**Subject: Auditorium Assessment**

I respectfully submit to you this technical letter that provides information regarding the potential impact to aeronautical operations caused by the proposed construction of an auditorium near the site of the proposed Nuevo Aeropuerto Internacional de la Ciudad de México (NAICM).

**Figure 4. Proposed Auditorium and Perimeter in Relation to the MITRE-Recommended Runway Configuration (July 2012) at NAICM**

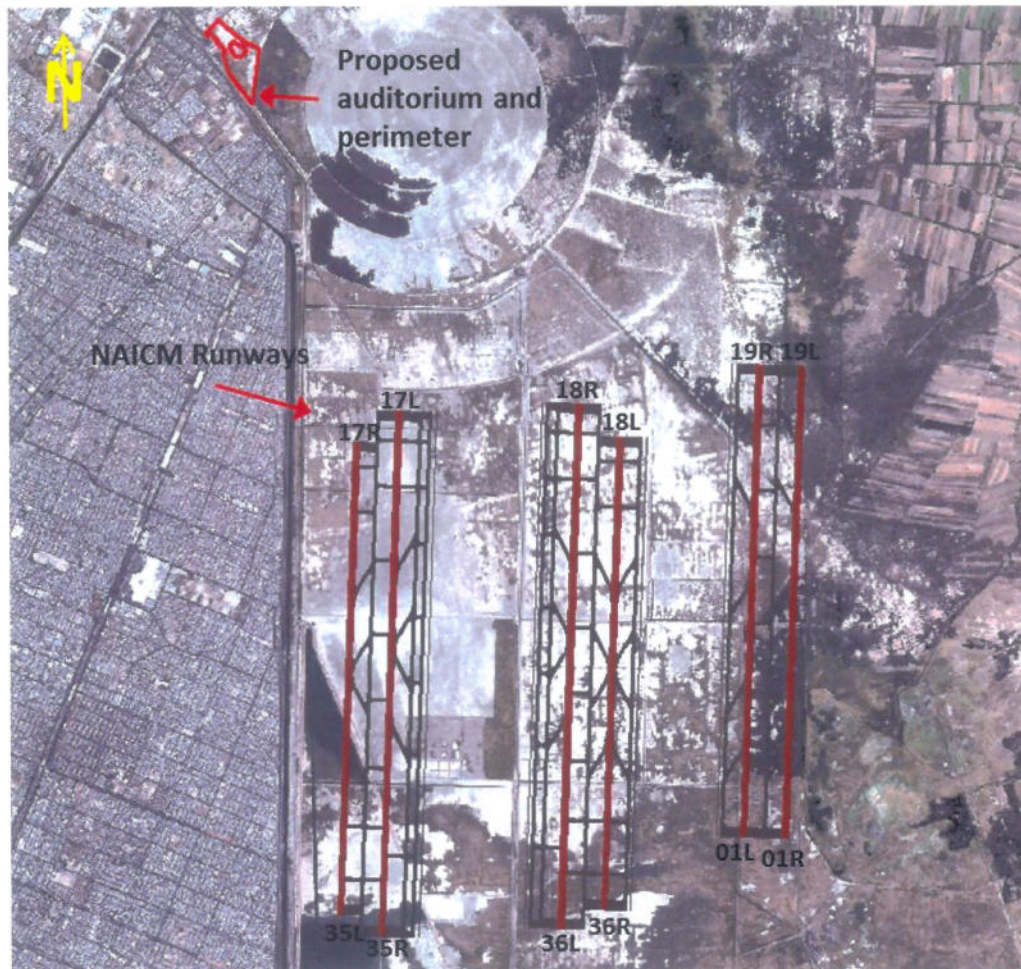
For the purposes of this assessment, MITRE evaluated the impact of the auditorium on the NAICM proposed runway configuration shown below in Figure 4, referred to as the *MITRE-Recommended Runway Configuration (July 2012)*, that was proven feasible during a previous project.

**Figure 5. NAICM Inner Horizontal Surface and Conical Surface**

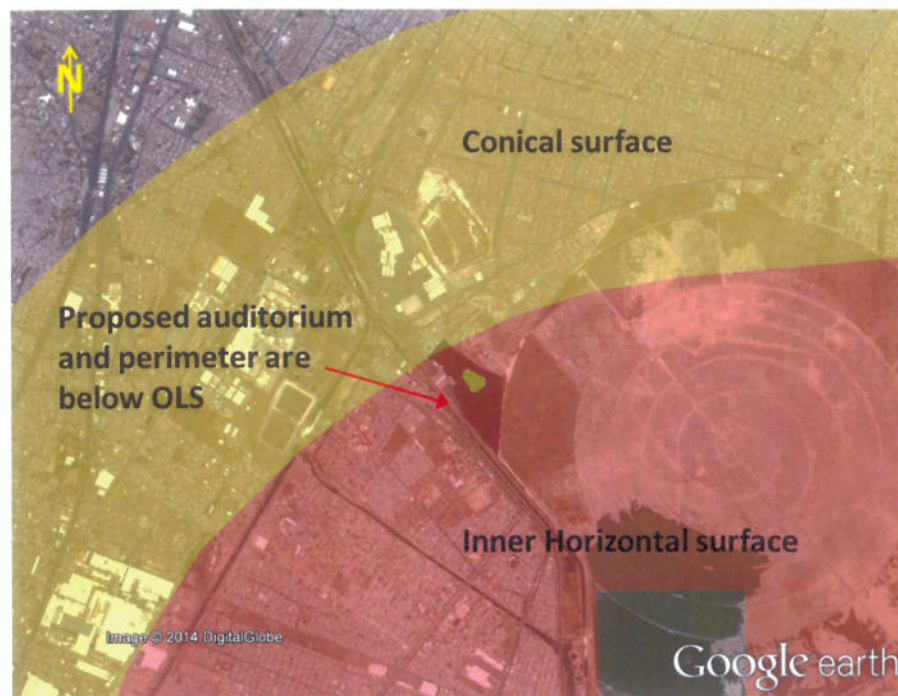
MITRE evaluated the impact of the auditorium and perimeter against ICAO Annex 14 OLS. However, given the location of the auditorium, the relevant surfaces to this assessment were the Inner Horizontal and Conical surfaces. Figure 5 shows the location of the auditorium and perimeter in relation to the Inner Horizontal and Conical surfaces.

MITRE used an airport datum elevation of 2223 m MSL at NAICM to establish the Inner Horizontal. As a result, the elevation of the Inner Horizontal surface is 2268 m MSL, a height greater than the auditorium (2257.105 m MSL) and perimeter (2241.105 m MSL). Therefore, while both the auditorium and perimeter fall within the lateral confines of the Inner Horizontal and Conical surfaces, they do not penetrate either surface and cause no impact to ICAO Annex 14 OLS.

**Figure 6. ILS RWY 35L CAT II/III Missed Approach**

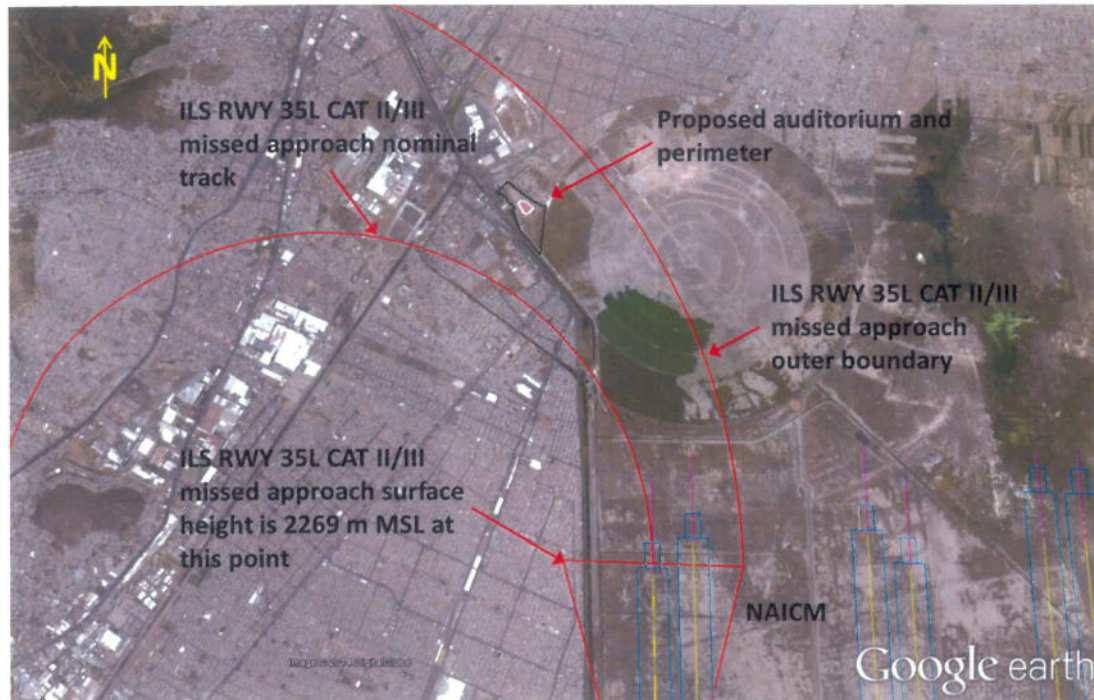
The ILS RWY 35L CAT II/III approach represents the worst-case northbound approach in relation to the auditorium and perimeter, and is shown in Figure 6. The auditorium and perimeter are within the lateral confines of the missed approach surface. However, they do not penetrate the surface. Similarly, MITRE analyzed all of the above-mentioned northbound approaches and determined that the proposed auditorium and perimeter would not impact these procedures.

**Figure 8. RNP AR RWY 35L Missed Approach**

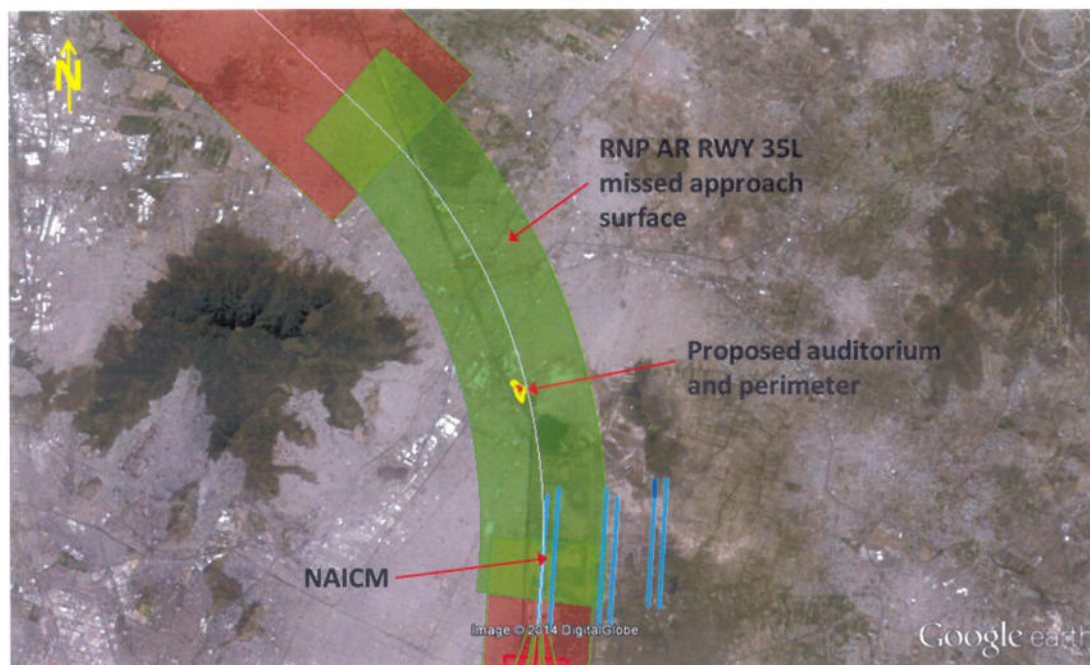
The RNP AR RWY 35L approach represents the worst-case northbound approach, and is shown in Figure 8. The auditorium and perimeter are within the lateral confines of the missed approach surface. However, they do not penetrate the surface. Similarly, MITRE analyzed all of the above-mentioned northbound approaches and determined that the proposed auditorium and perimeter would not impact these procedures.

**Figure 9. RNP AR RWY 17R Final Approach**

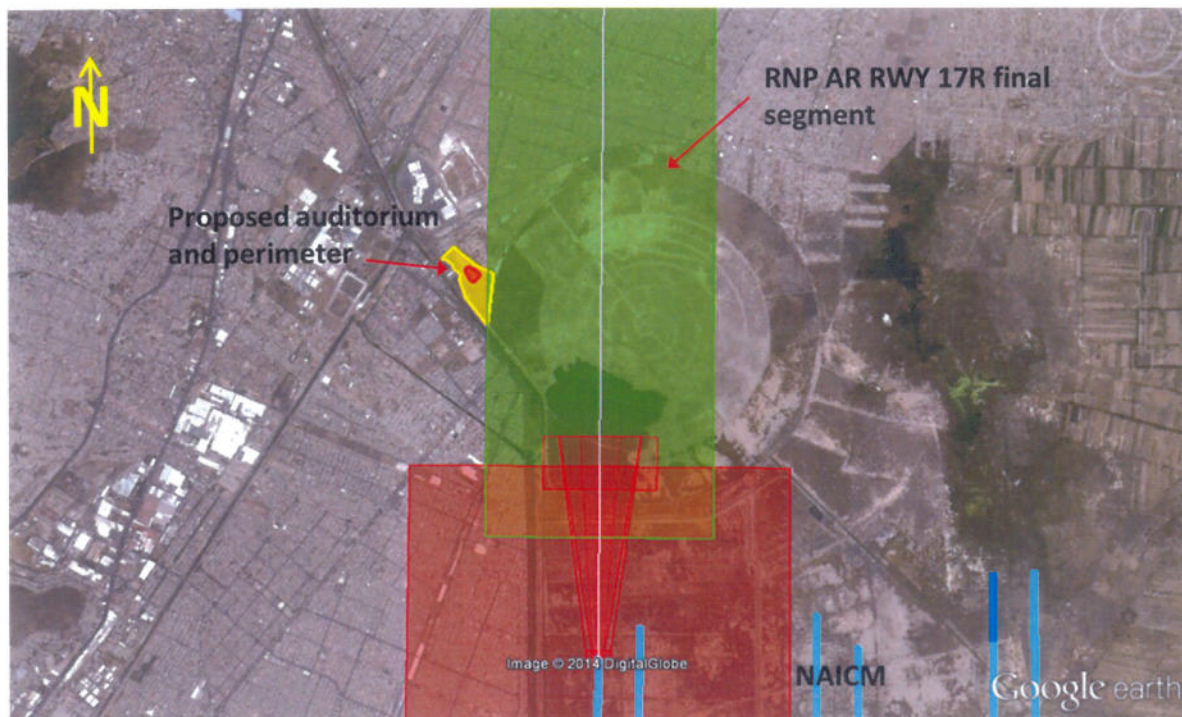
The RNP AR RWY 17R approach represents the worst-case southbound approach, and is shown in Figure 9. The auditorium is completely outside of the lateral confines of the final segment. However, a portion of the perimeter is within the lateral confines of the final segment. Neither the auditorium nor the perimeter penetrates the surface. MITRE analyzed

all of the above-mentioned southbound approaches and determined that the proposed auditorium and perimeter would not impact these procedures.

**Figure 11. RWY 35L U.S. and ICAO Engine-out Obstacle Assessment Areas**

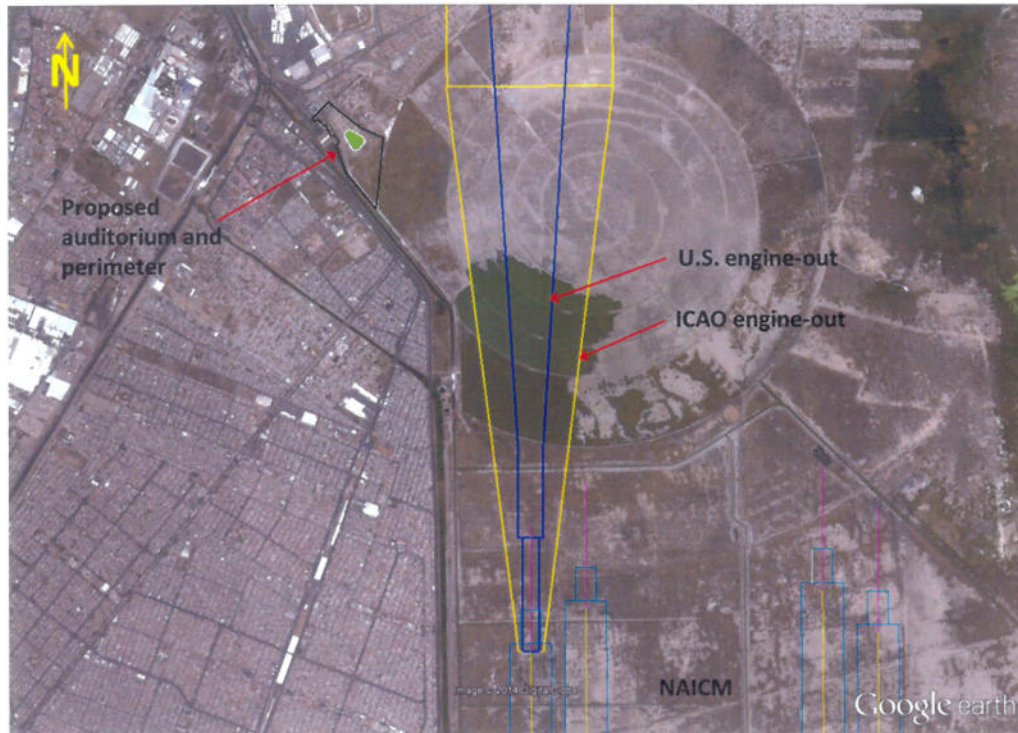
MITRE determined if the auditorium and perimeter would be located within or in the vicinity of notional U.S. or ICAO engine-out obstacle assessment areas, which could potentially result in adverse operational impacts on future aircraft operations. Figure 11 shows the notional straight-ahead portion of U.S. and ICAO engine-out obstacle assessment areas for RWY 35L (the runway closest to the auditorium) in relation to the proposed auditorium and perimeter. Neither is located within the lateral confines of the U.S. or ICAO engine-out obstacle assessment areas and therefore, the proposed auditorium and perimeter should not impact these notional engine-out obstacle assessment areas.

It is important to reiterate that airlines are responsible for developing their own engine-out procedures. Therefore, the engine-out procedure and its associated obstacle assessment areas considered by MITRE for its assessment of the auditorium may be different than the procedures and surfaces developed by airlines. Nevertheless, MITRE feels that airlines would likely develop an engine-out procedure for RWY 35L that initially goes straight-ahead for several miles to avoid populated areas for as long as possible, and to allow aircraft to achieve best climb performance.

**Figure 12. Noise Exposure, South Flow, Scenario 3**

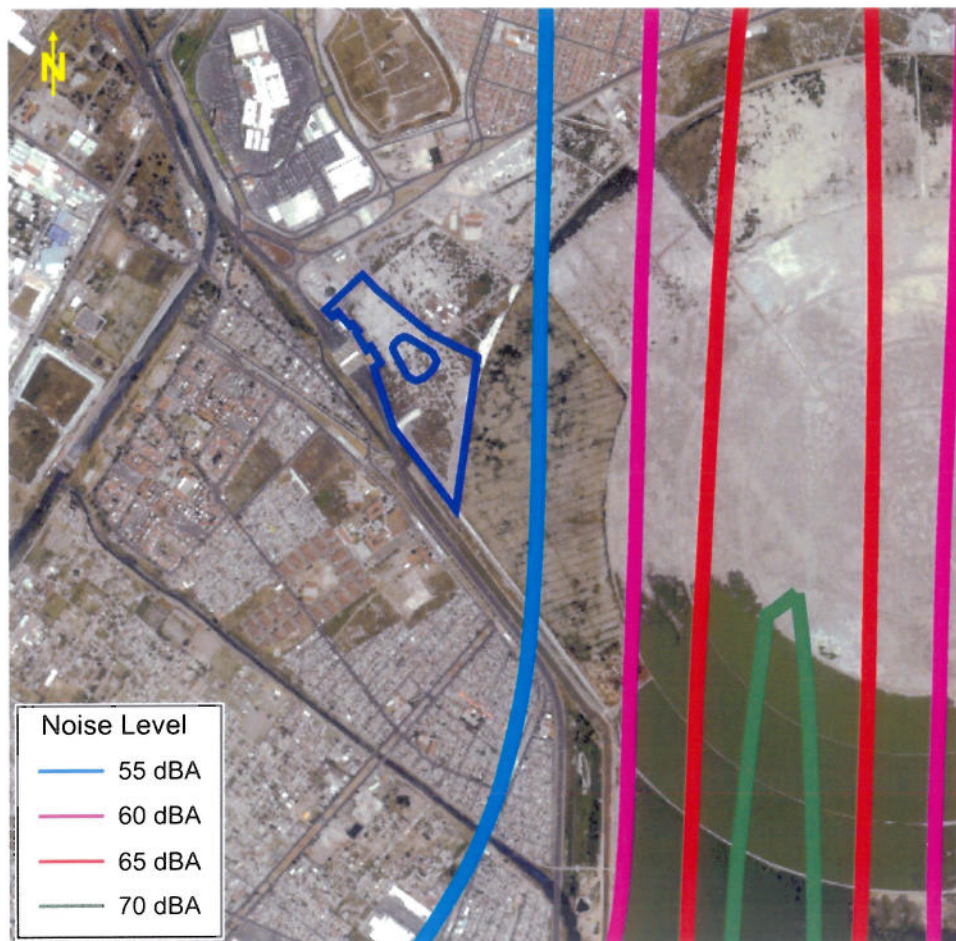
For south-flow operations, the worst-case scenario was Scenario 3 listed above, since this scenario had the highest traffic level and approaches were assumed to land on the westernmost runway (the auditorium would be affected primarily by arrivals in south flow and primarily by departures in north flow). For this scenario, the auditorium could experience noise exposure at approximately the 50 dBA level (see Figure 12), which would be acceptable.

**Figure 13. Noise Exposure, North Flow, Scenario 3**

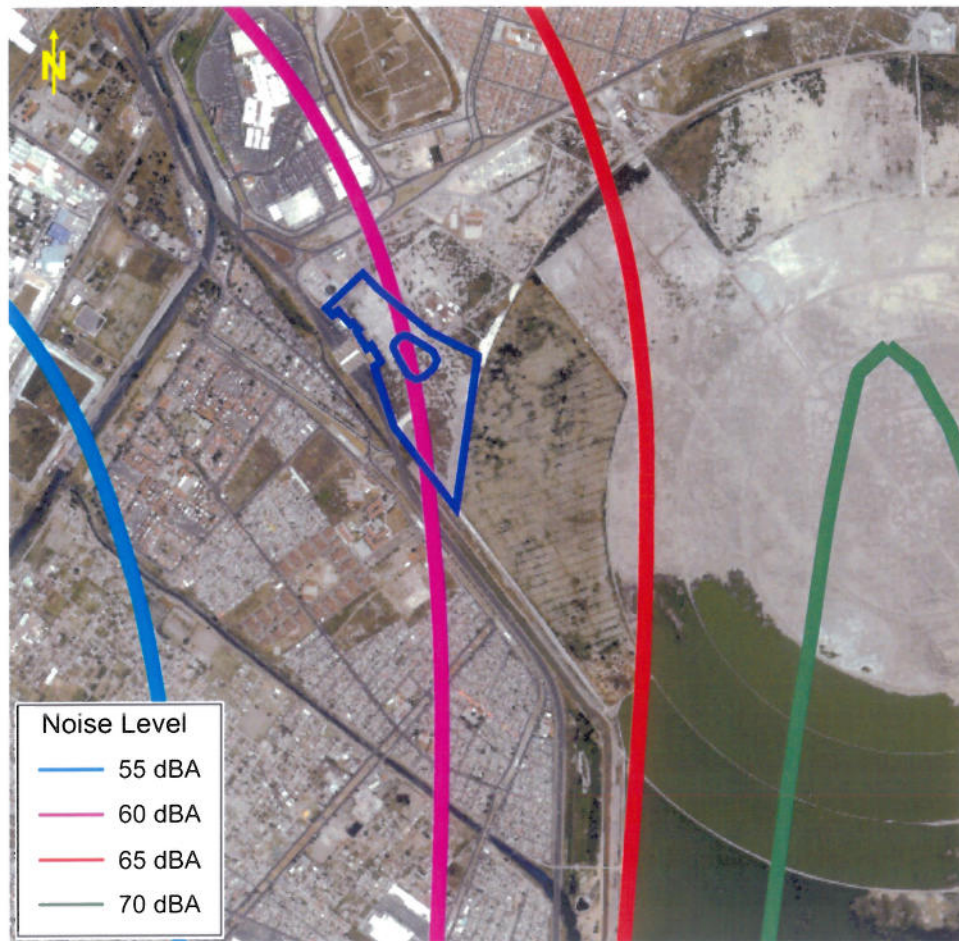
For north-flow operations (which will likely be used a high percentage of the time due to the prevailing winds), the noise exposure at the auditorium would be much higher than in south flow. For Scenario 3, the ultimate six-runway configuration with aircraft departing on RWY 35R (i.e., the runway adjacent to the westernmost runway), the auditorium could experience noise exposure at approximately the 60 dBA level, with portions of the auditorium and the eastern portion of the perimeter experiencing slightly higher dBA levels. See Figure 13. These noise levels would be marginally unacceptable.

Concerning noise, it is important to note that the expected noise exposure is deemed marginally- to potentially-unacceptable given historical U.S. land-use guidelines. Therefore, consideration should be given to noise mitigation measures, such as soundproofing of the auditorium in order to help reduce potential noise impacts caused by NAICM operations.

**Figure 14. Noise Exposure, North Flow, Scenario 2**

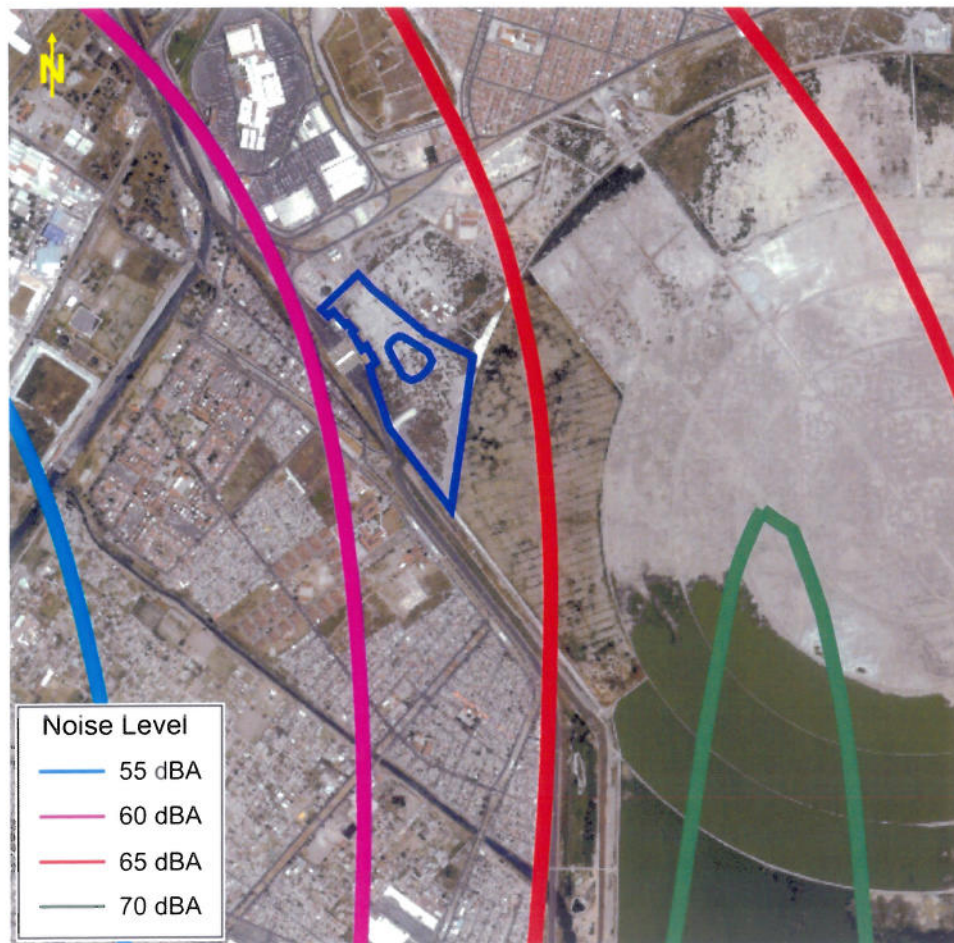
Next, although MITRE's previous noise analysis results pertaining to Scenarios 1 and 2 do not apply to the revised opening-day runway configuration at NAICM (i.e., consisting of RWY 35R/17L instead of RWY 35L/17R) by ASA, those results still provide some helpful information. For example, another important consideration is the noise exposure that could occur over the auditorium in the future once RWY 35L/17R is constructed and RWY 35R/17L is closed for maintenance or other reasons. In that case, MITRE's previous noise analysis results pertaining to Scenario 2 (with departures assigned to RWY 35L) would be applicable, as shown in Figure 14. In this case, Scenario 2 shows that the auditorium (including the perimeter) could experience noise exposure at about the 61-63 dBA level, which would be normally unacceptable.
